REGULATORY INFORMATION DISTRIBUTION SYSTEM (RIDS)

SUBJECT: Forwards 800508 sys review transcript re Class IE power sys.
Review held before Power Sys Review Board in Phoenix, AZ.
Pp 1-179.

12 The purpose of this meeting today is to perform a
13 system review of the Palo Verde Nuclear Generating Station
14 Class IE dc power system. The concept of performing a system
15 review was discussed in recent meetings with NRC Director for
16 Nuclear Reactor Regulation, Dr. Harold Denton. With this
17 concept, the design of a plant system is thoroughly reviewed
18 and presented to a review board by an expert in the technical
19 disciplines encompassed by that system. This review and
20 presentation would assist NRC in understanding the system
21 design and operation, thereby minimizing the review manhours
22 required for that particular system.

FIGURE 8

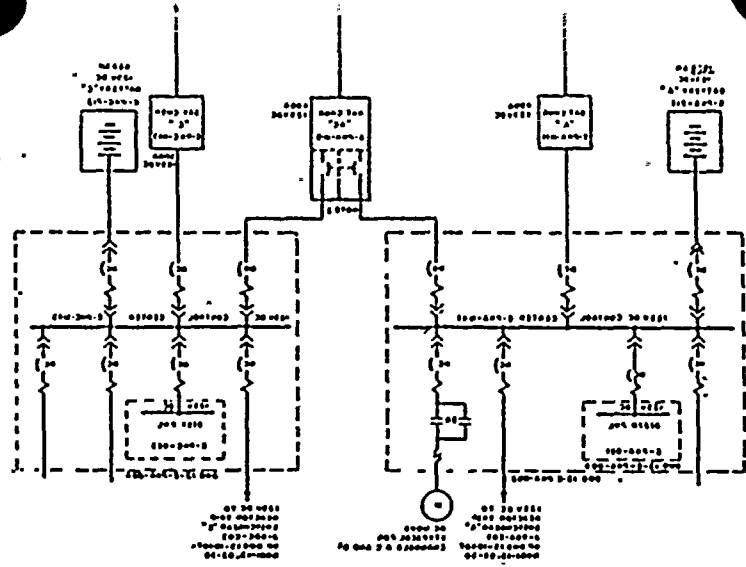
7 MR. TAJADDODI: Yes. The standby charger or the swing
8 charger, as it is called, has got two output breakers which
9 can swing to either A or C channels (Figure 8). These breakers
10 are mechanically interlocked. They are interlocked such that
11 no two breakers are going to be closed simultaneously. Only
12 one breaker is going to be closed simultaneously. The two
13 breakers are air breakers and isolated with a barrier between
14 them to meet the requirements of Reg. Guide 1.75 and IEEE 384.
15 In addition to that, there are two additional breakers in
16 series with those breakers that are connected to the charger.
17 As can be seen on this chart in here (indicating) the two
18 breakers in series here are normally open with the chargers
19 on standby condition. If the charger is on supplying power,
20 this charger is completely disconnected with these breakers
21 open. So no fault or no failure in the charger can jeopardize

14 MR. TAJADDODI: It is in the handout, yes. It is right
15 ahead of another drawing (Figure 8) which shows all four channels.

FIGURE 9

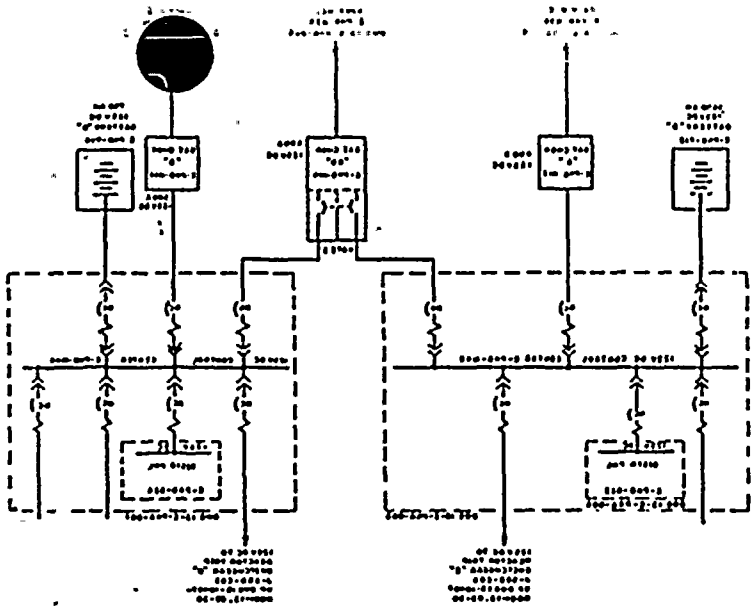
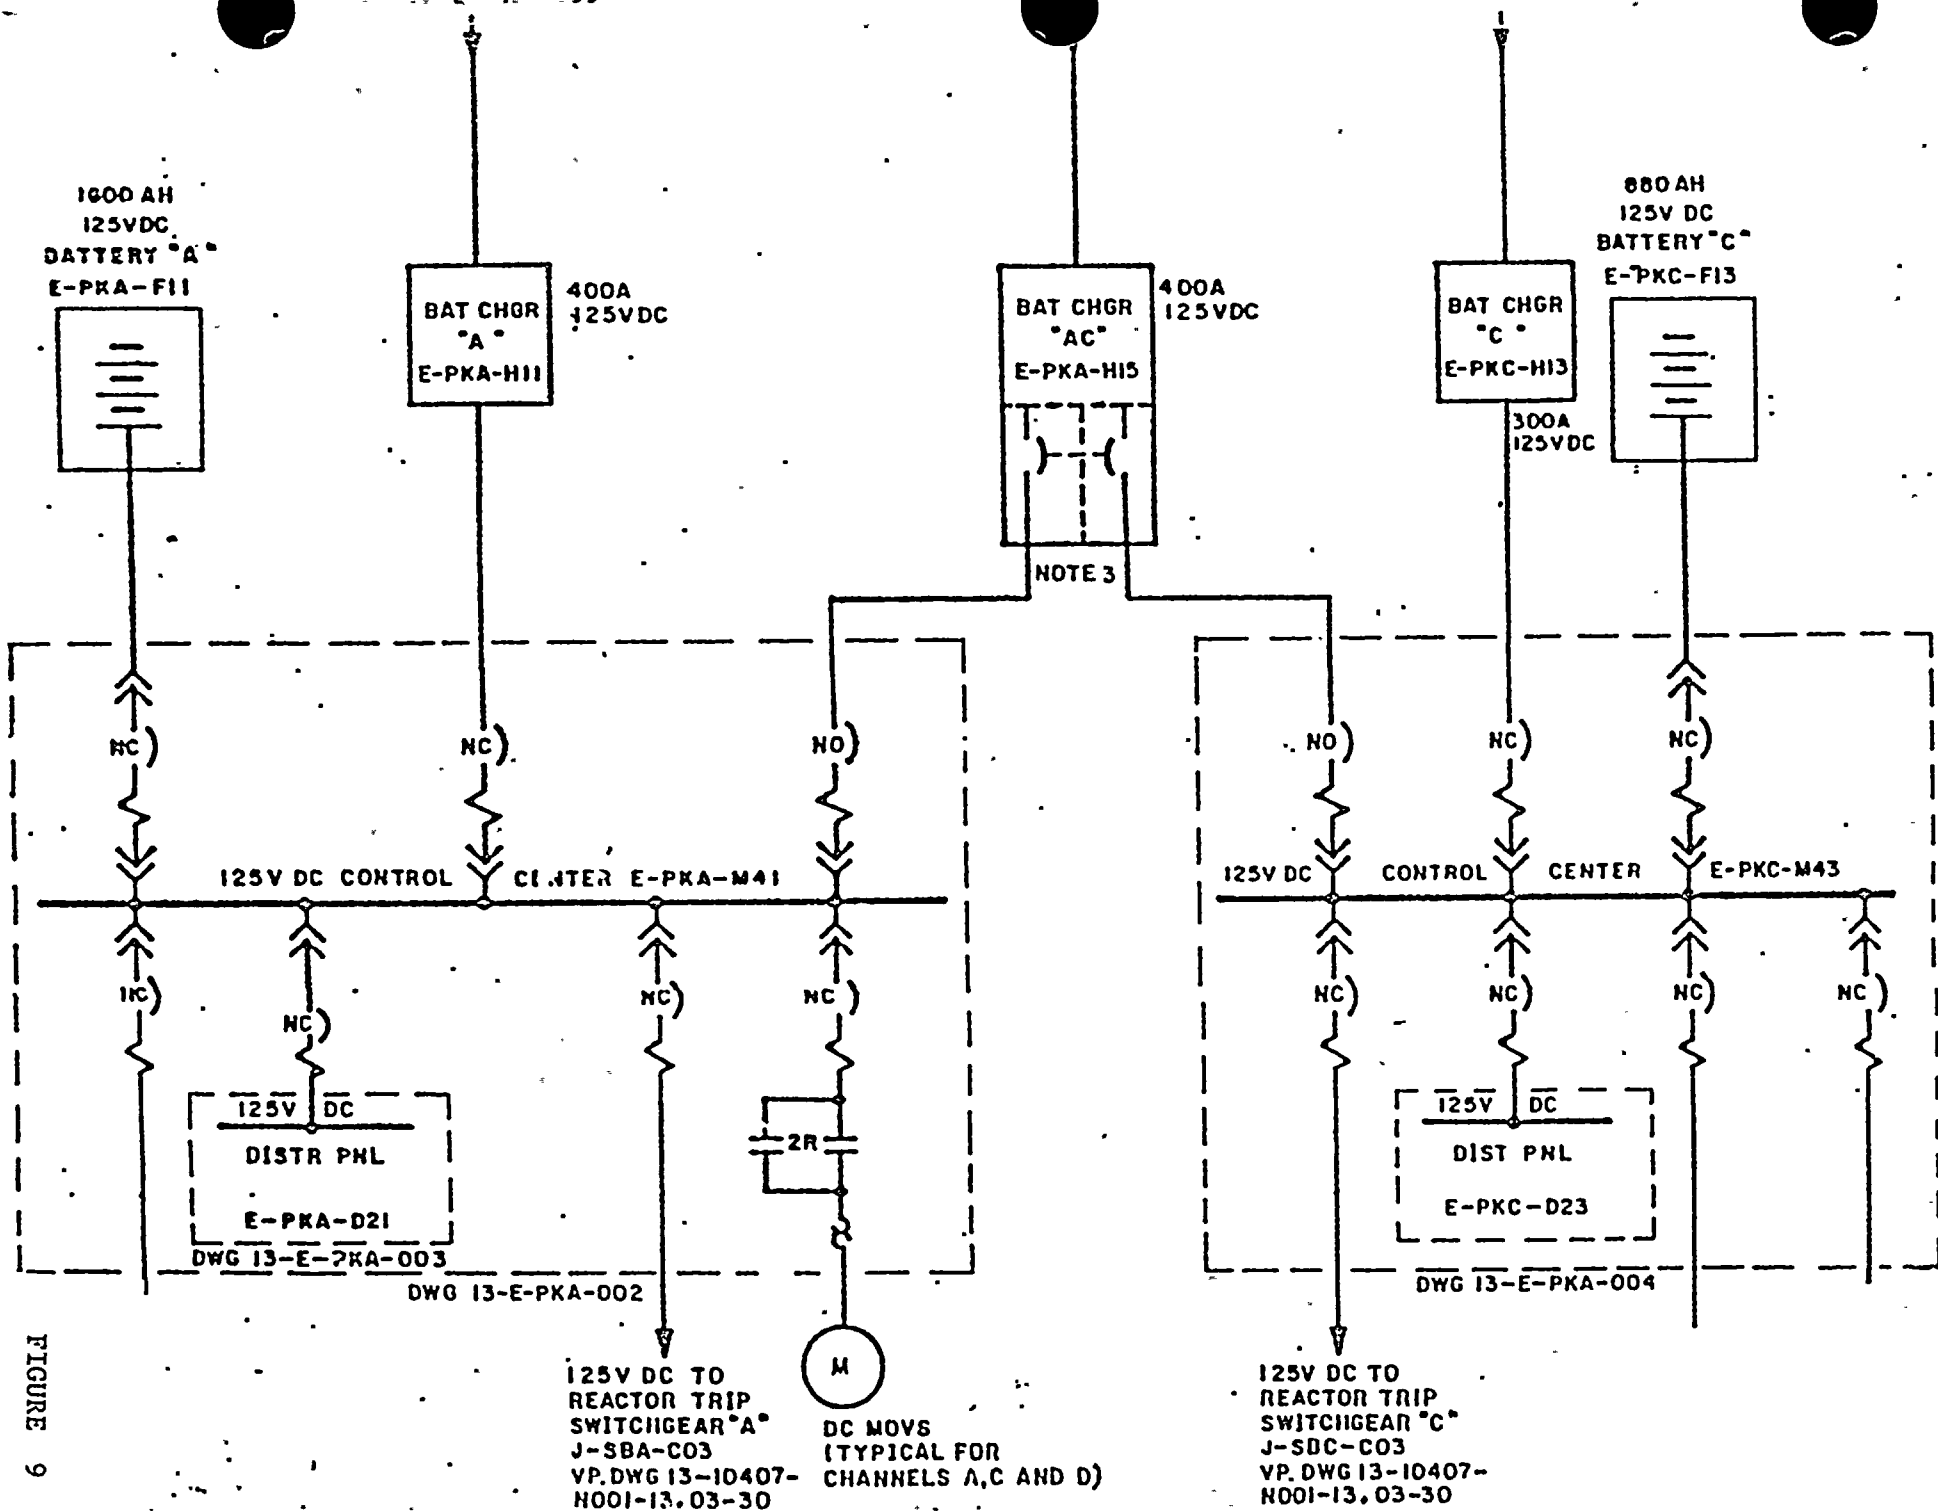
10 MR. TAJADDODI: The chart that I am using (Figure 9) is a
11 one-line diagram of the dc system on systems A and C, which is
12 a sample. The same thing is true for channels B and D.

16 MR. PAUL: I would like to ask a question. Is it
17 necessary to have magnetic trips in the circuit to the dc bus
18 and are they reliable?

21 MR. PAUL: Another question. What is the fault
22 interruptible capability of that breaker?

FIGURE 10

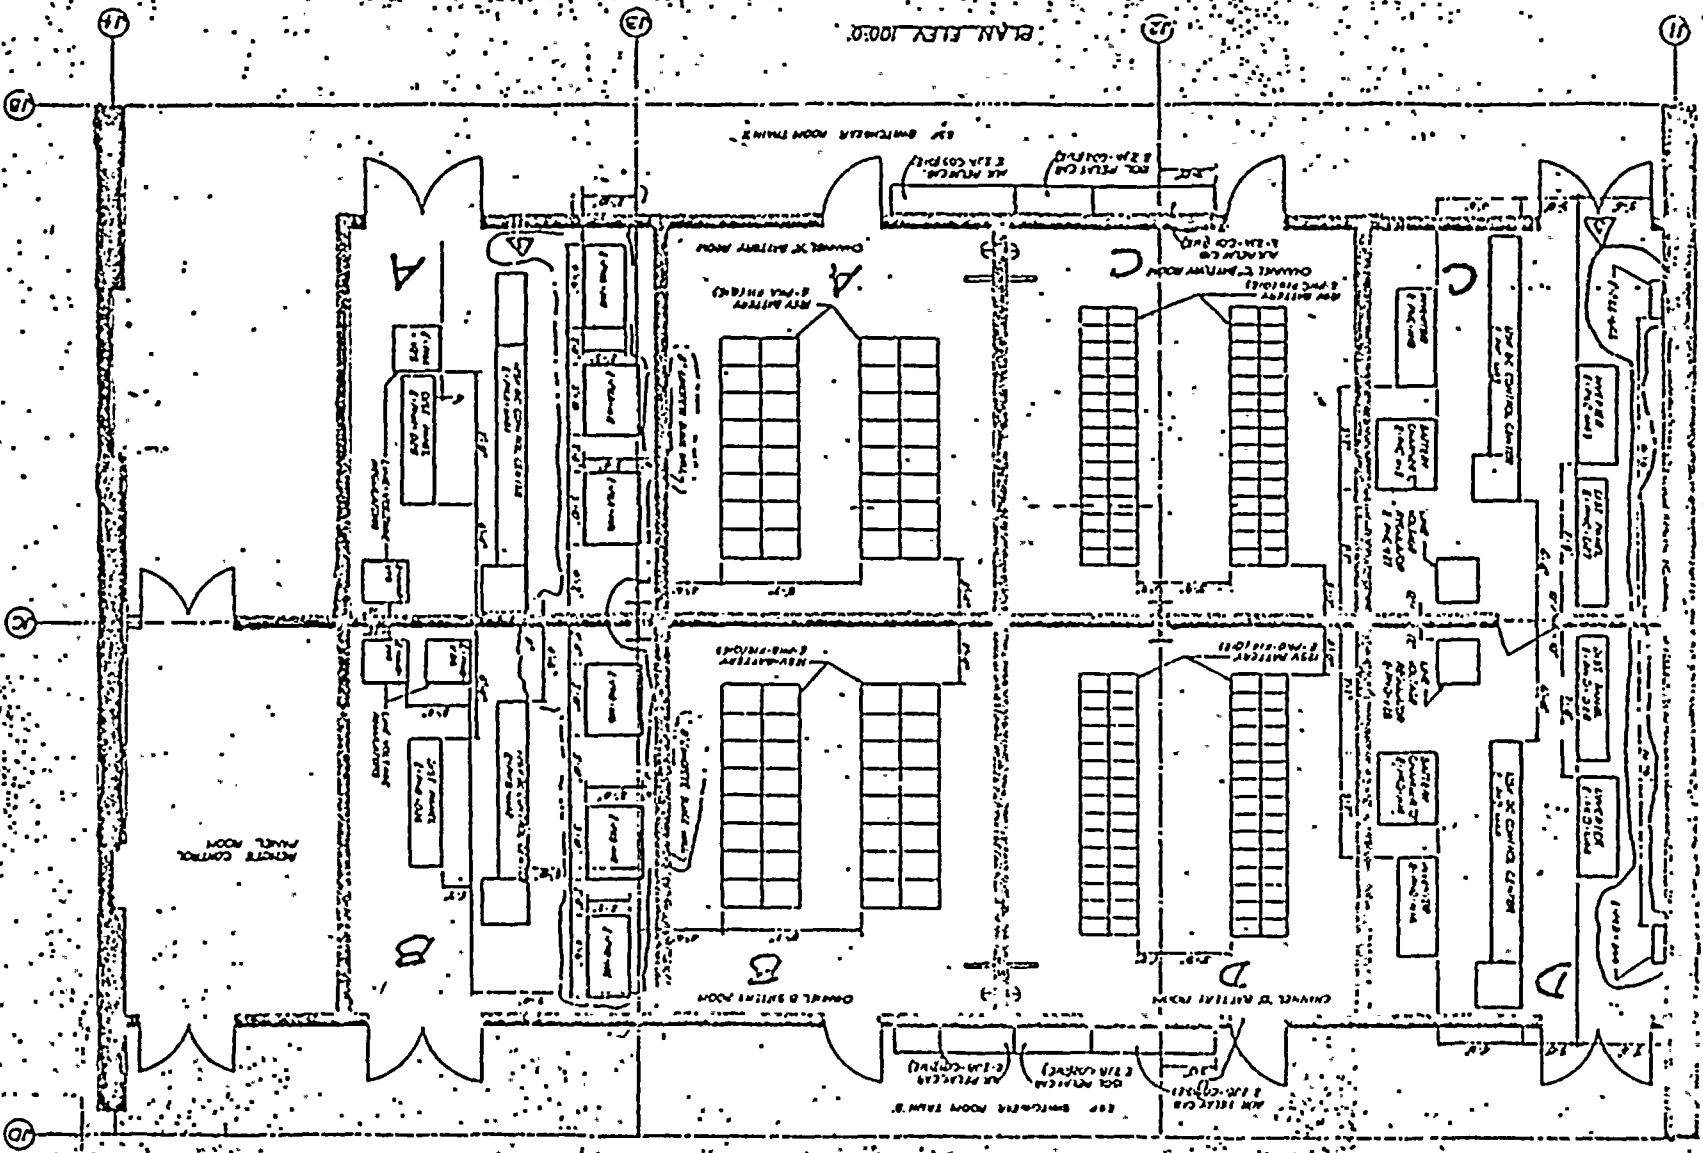
9 MR. FREID: If we go back to the physical drawing that we
10 had [Figure 10], the question is on independence between the trains.
11 You show a door between C channel and D channel, which is a
12 door between two trains. In the design criteria, I haven't
13 seen the general section, but I assume in your general HVAC
14 section, you have criteria for assuring that there is no
15 cross-connection between trains due to the HVAC channel.
16 However, is there a security system that assures that that
17 door is closed?

FIGURE 31

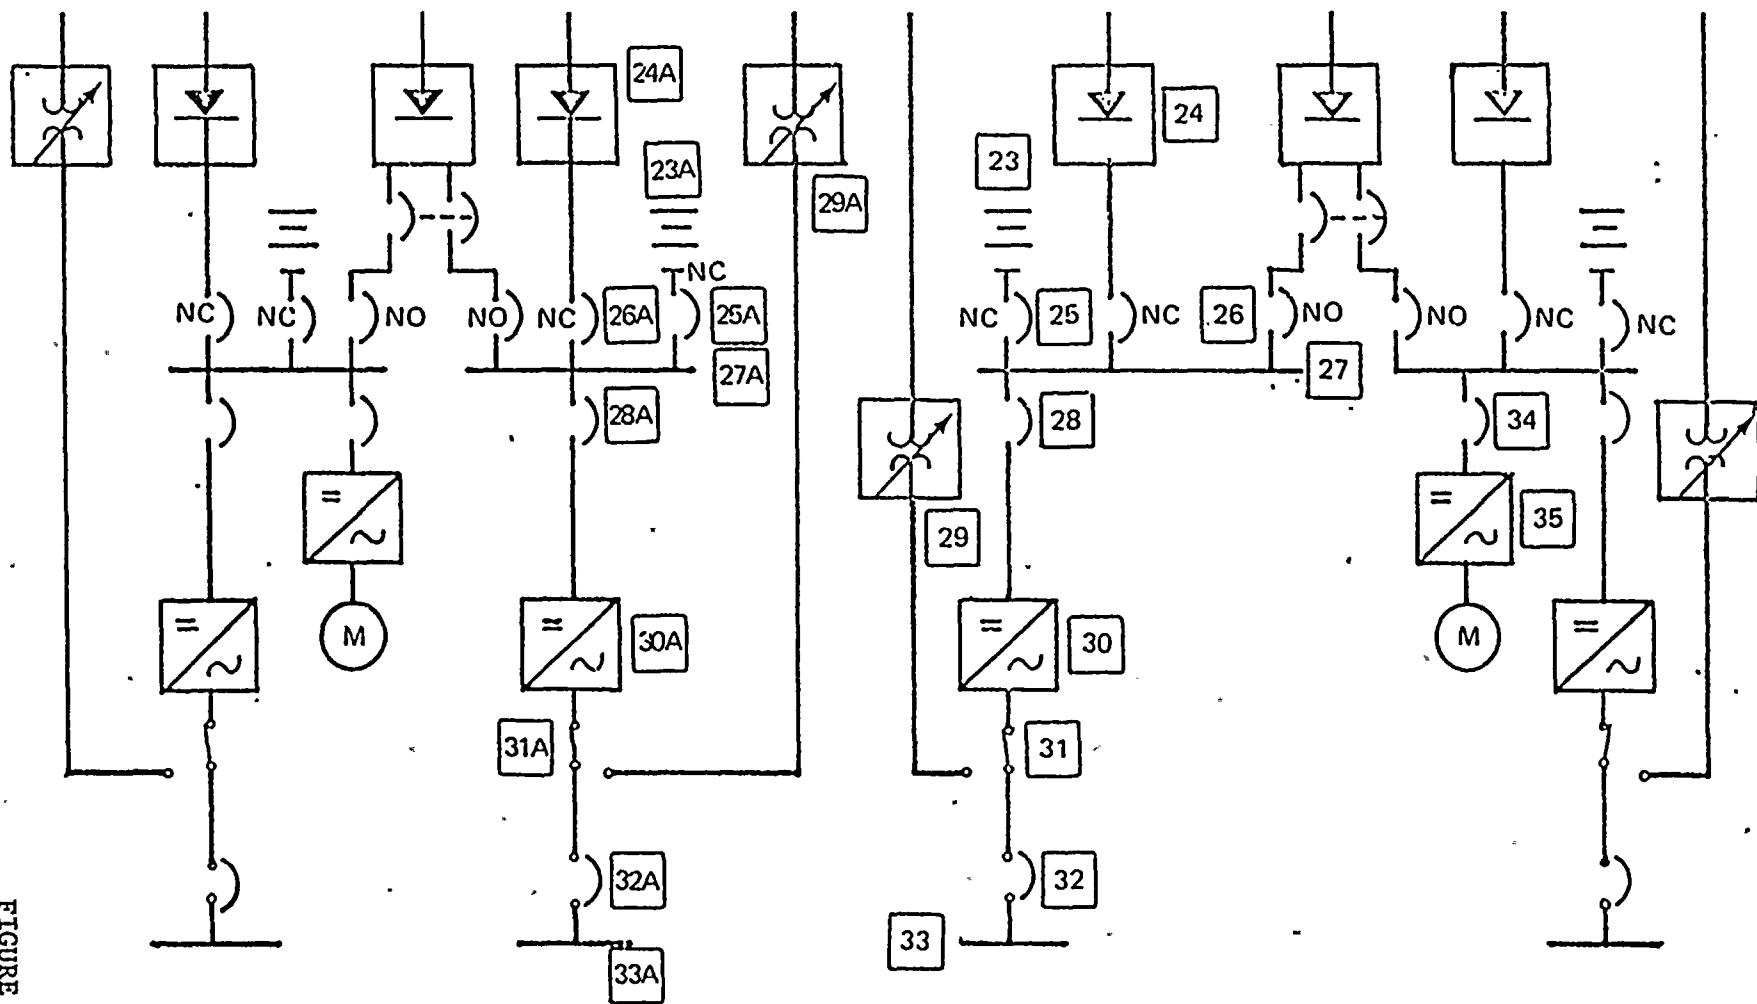
24 MR. TAJADDODI: We have drawn the system that we are
25 going to discuss. [Figure 31] The failure mode and effects analysis --

1 actually, the system stops right here (indicating). This
2 (indicating) is the additional system that shows the whole
3 interface. We have numbered all these breakers as to what
4 each of these breakers is going to, what will be the effect
5 of each of those components failing from the charger, batteries,
6 the breakers, the buses, all the way down, and the following
7 chart (Figure 32) gives a descriptive analysis of the failure
8 of each of those items. These items are shown in your
9 left-hand column pertaining to this previous sketch. It
10 shows item number 23, which is a battery, and what will
11 happen to the system if there is a component malfunction.
12 It gives you its normal function, its failure mode, effect on
13 the subsystem, and it should be effect on the "system." If
14 we've got a battery malfunction, there will be loss of standby
15 power to the bus. However, the effect on the total dc system
